Bulletin – Truck loading augers ring gear

ECN ID #	ECN4479
DATE	July 23, 2024
BRAND	AGI, Westfield, Hutchinson, Mayrath, GrainMaxx
MODEL	STX2, XTA, UTX
DATE RANGE	July 1, 2024 - present
DETAILS	Truck loading augers - axle and ring gear wheels change

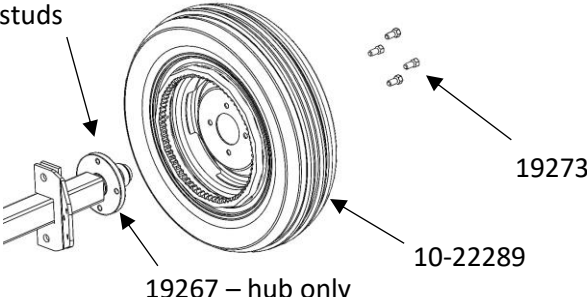
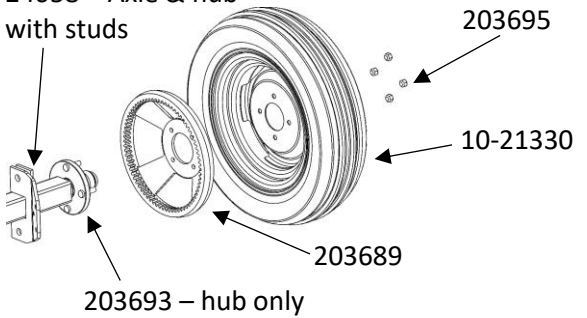
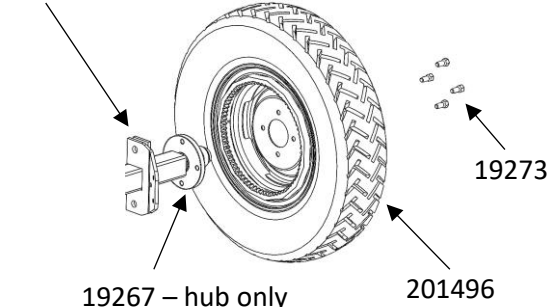
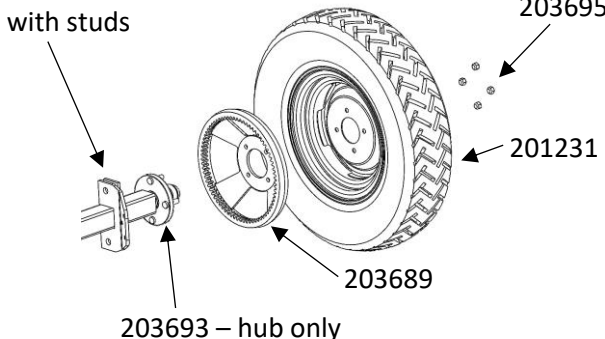
We have updated the style of ring gear that is used on our truck loading augers, which includes some hub changes on the axles along with that. The new hubs (PN: 203693) will now come with wheel studs as opposed to wheel bolts. The existing axles are backwards compatible with this change as well, see the table below for old and new part numbers that will be used.

For any dealers having unassembled stock of the old-style ring gears, please continue to use them up as a set on each unit.
